## ADDENDUM

**Campus HVAC System Upgrade  
Freemont Magnet Elementary School  
Bakersfield City School District  
566-0018  
DSA #03-122640**

**Subject: Addendum #003**

ADD-003.01

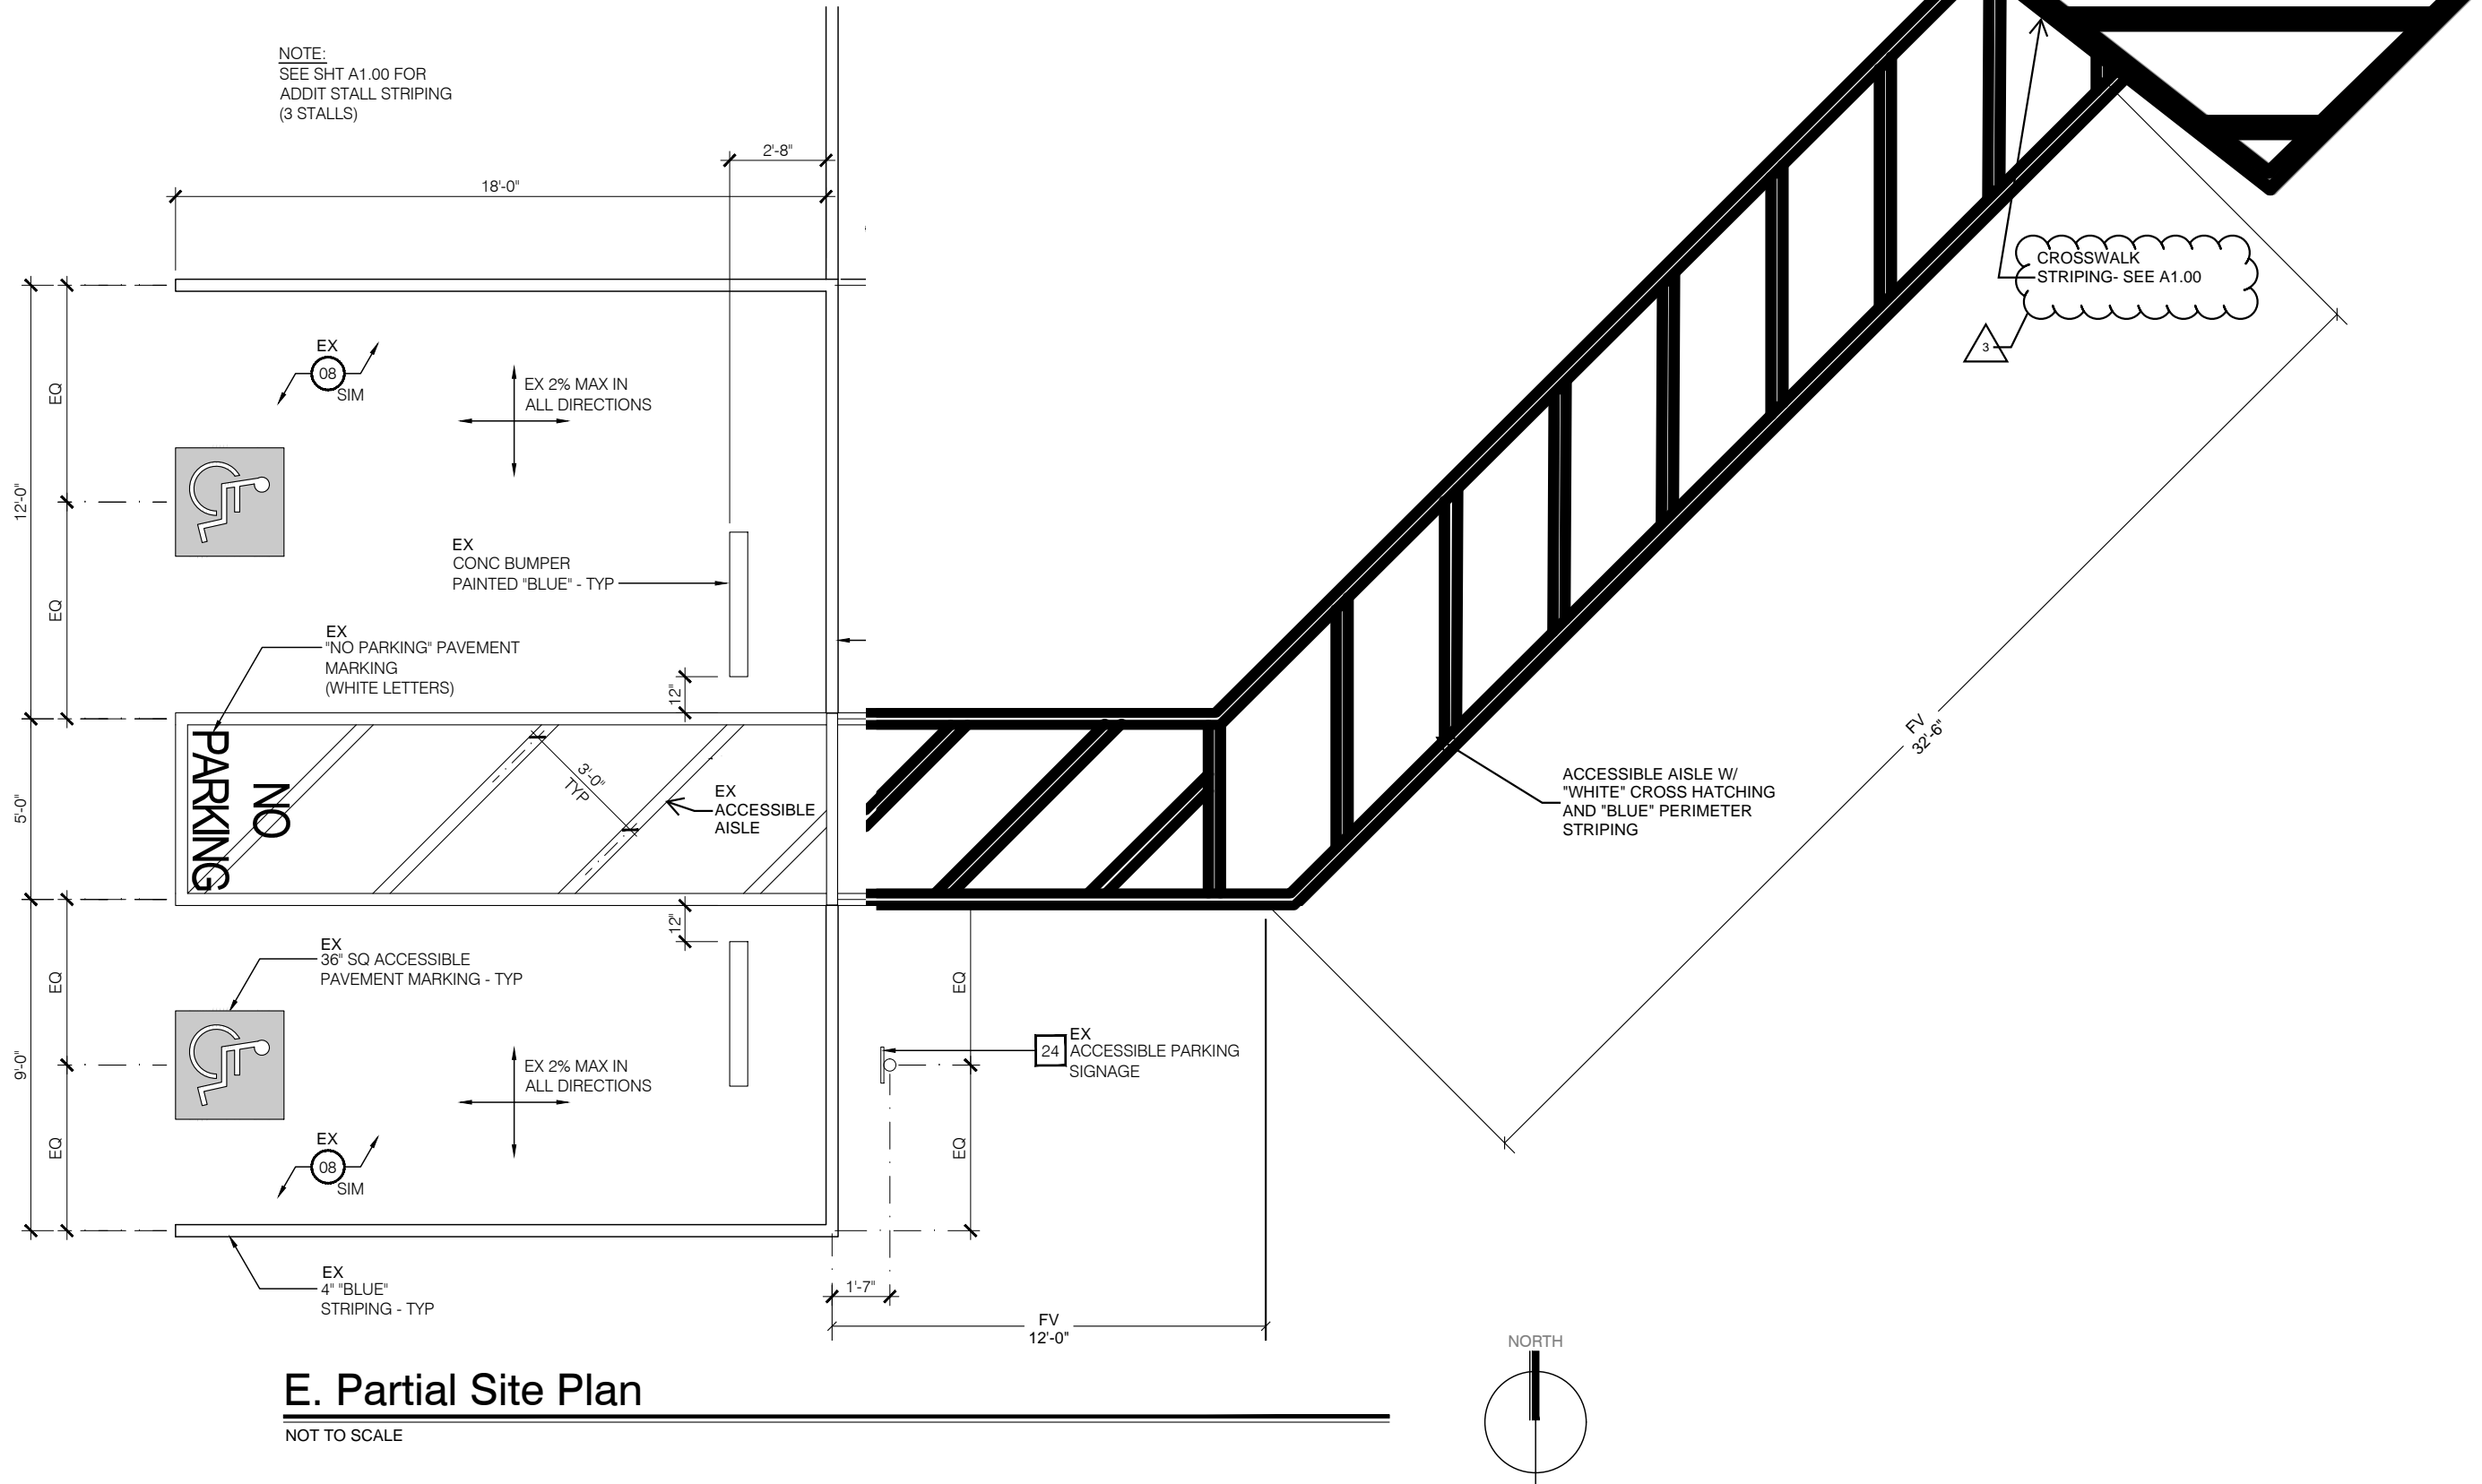
**3.7 Refer to Sheet A1.22:**

3.7.1 Refer to Partial Site Plan E:

3.7.1.1 Revise as indicated on attached Detail **ADD-003.01** as denoted by clouded areas with Delta "3".

**ADD-003.03**

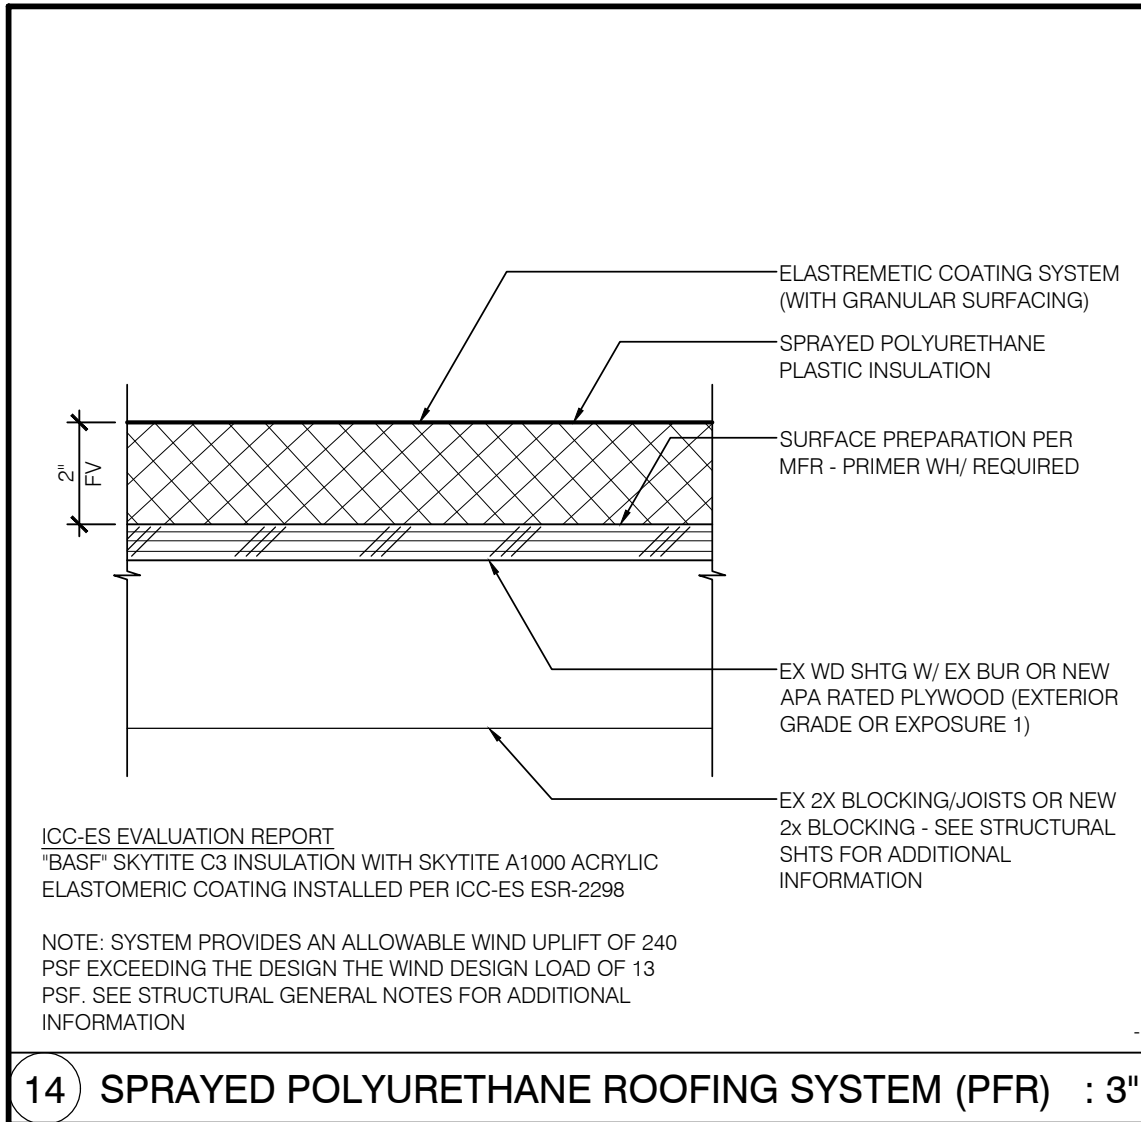
**3.9 Refer to Sheet A8.01:**

3.9.1 Refer to Detail 14:

3.9.1.1 Revise as indicated on attached Detail **ADD-003.03** as denoted by clouded areas with Delta "3".

**14 SPRAYED POLYURETHANE ROOFING SYSTEM (PFR) : 3"**

ADD-003.04

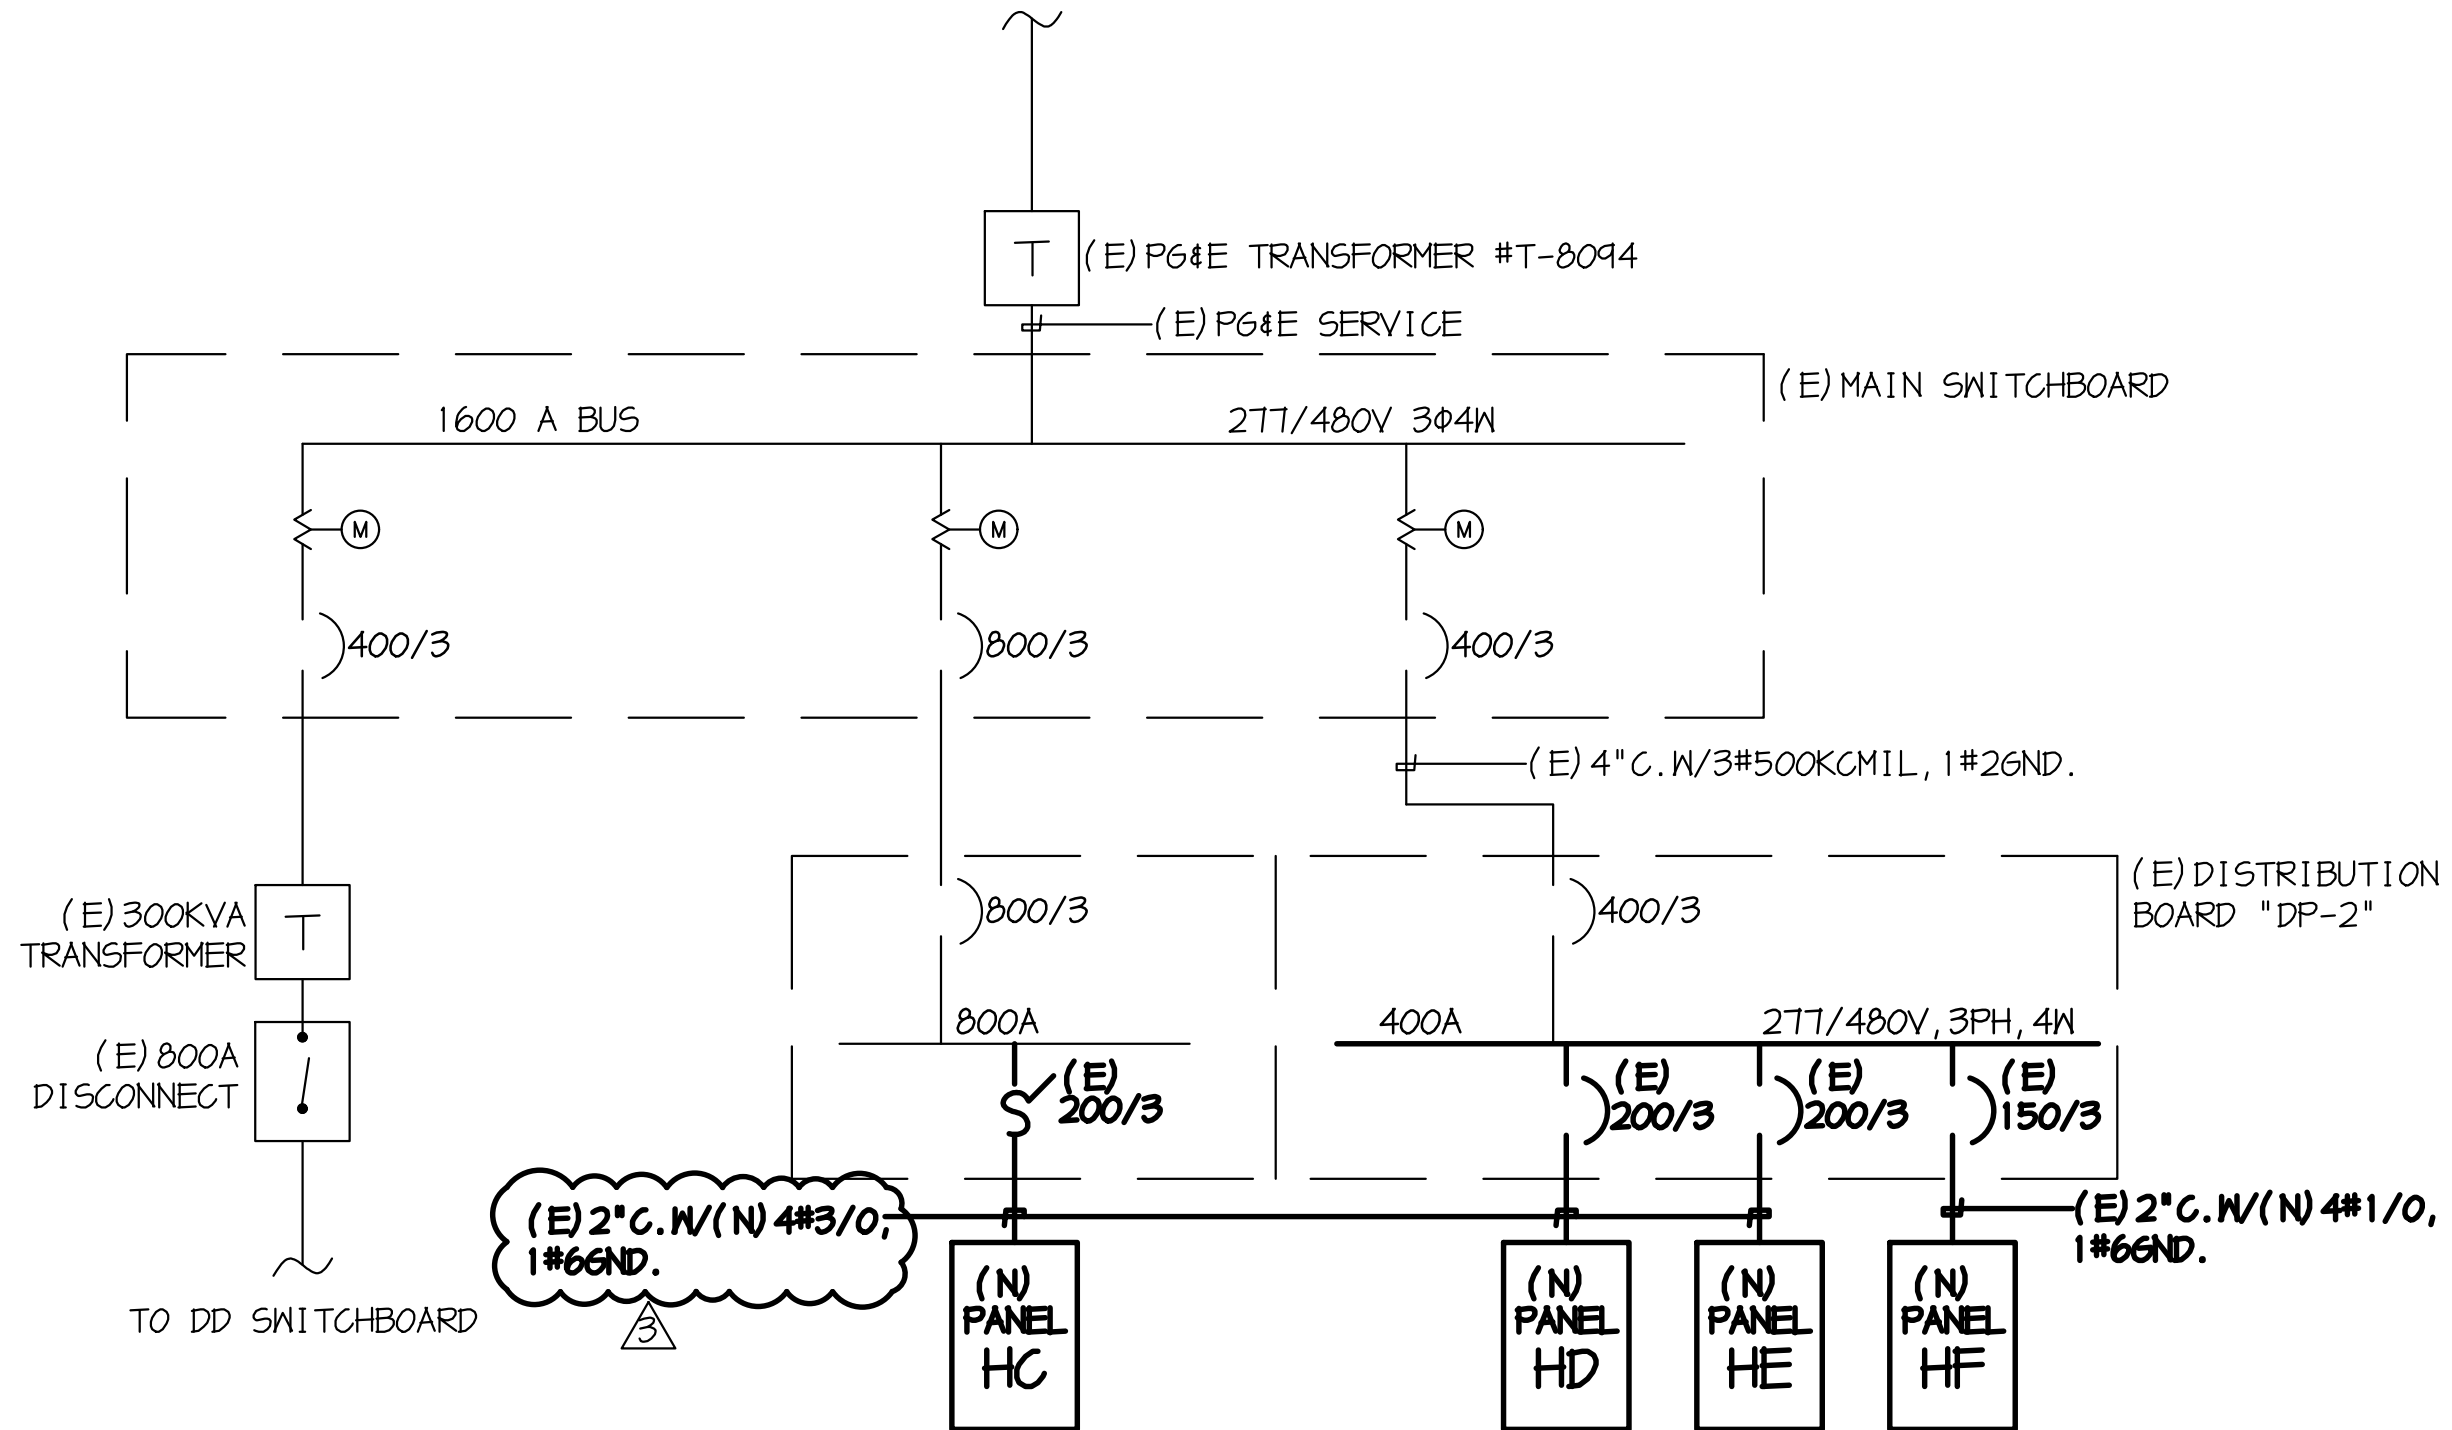
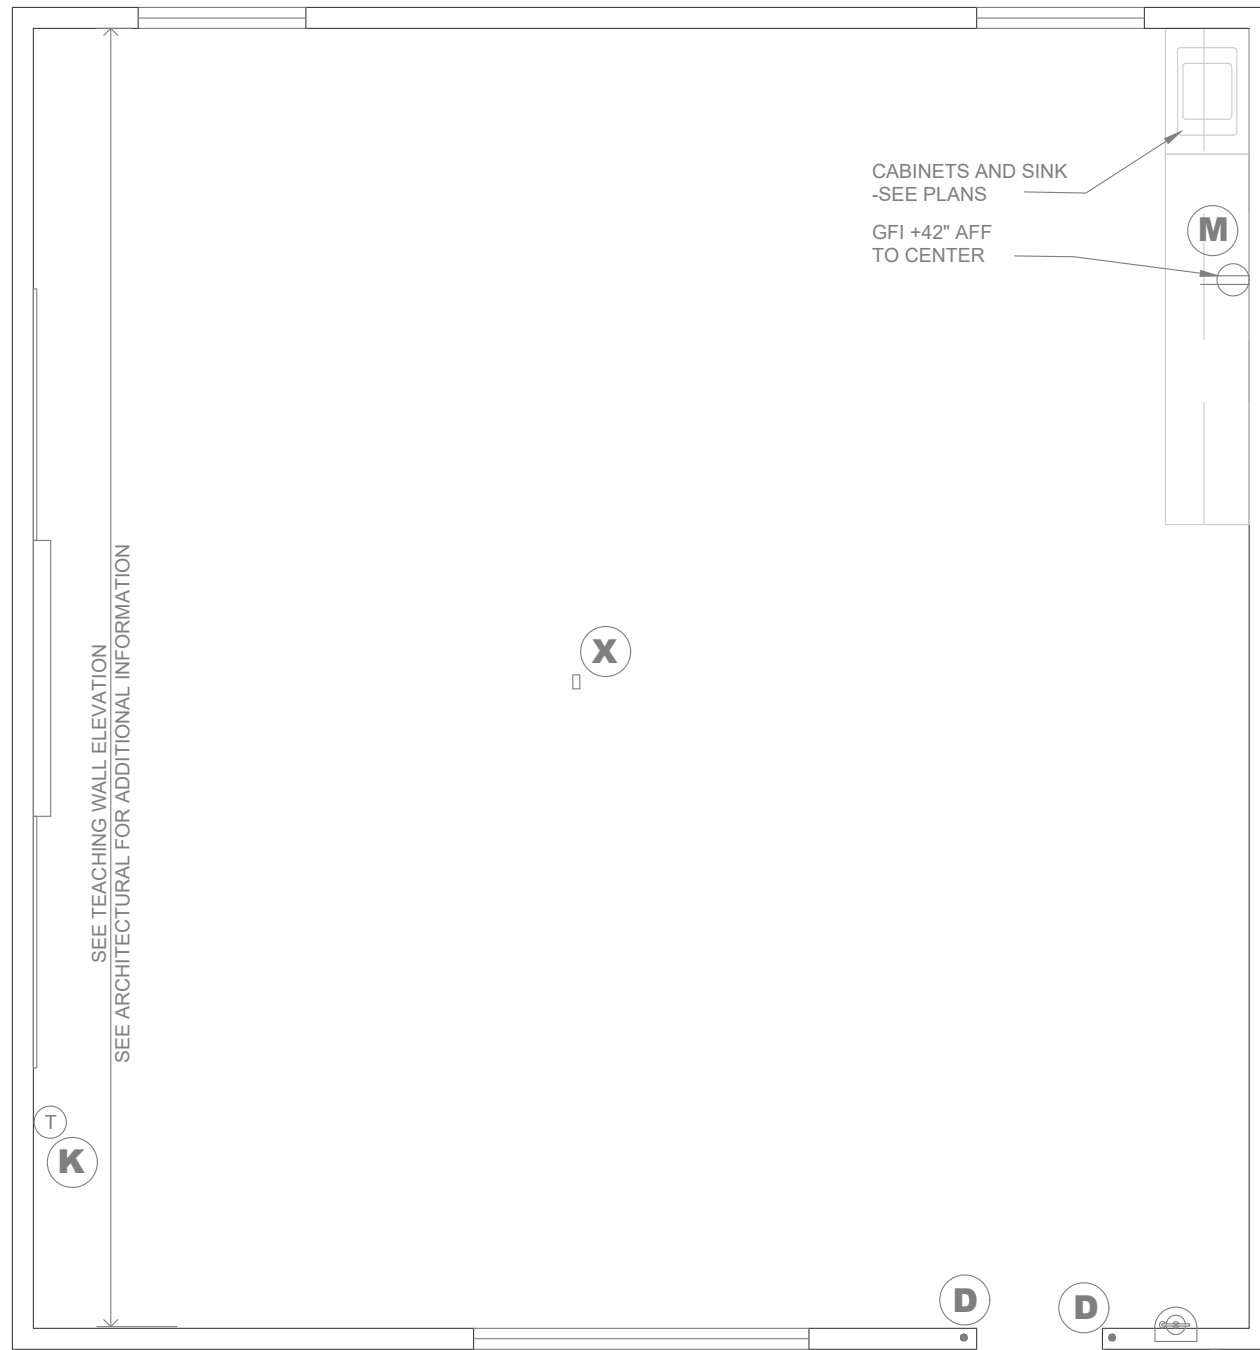
**3.10 Refer to Sheet E-001:**

3.10.1 Revise Single Line Diagram as indicated on attached Detail **ADD-003.04** as denoted by clouded areas with Delta "3".

TYPICAL CLASSROOM DETAIL

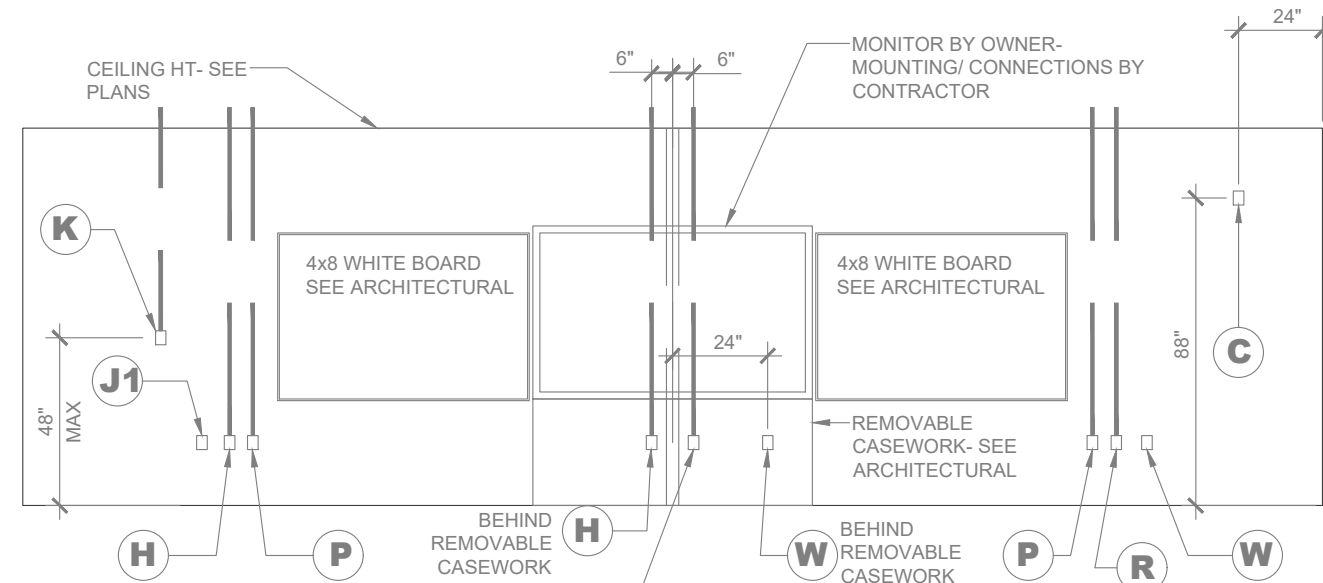
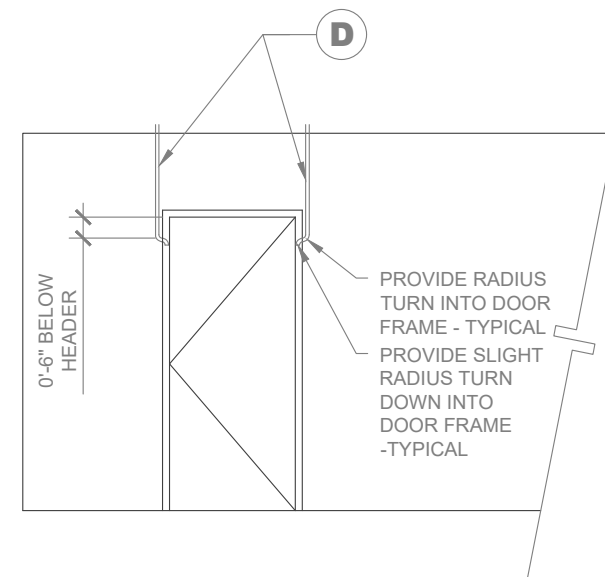
**3.11 Refer to Sheet E-005:**

3.11.1 Revise Detail "I" as indicated on attached Detail **ADD-003.05** as denoted by clouded areas with Delta "3".
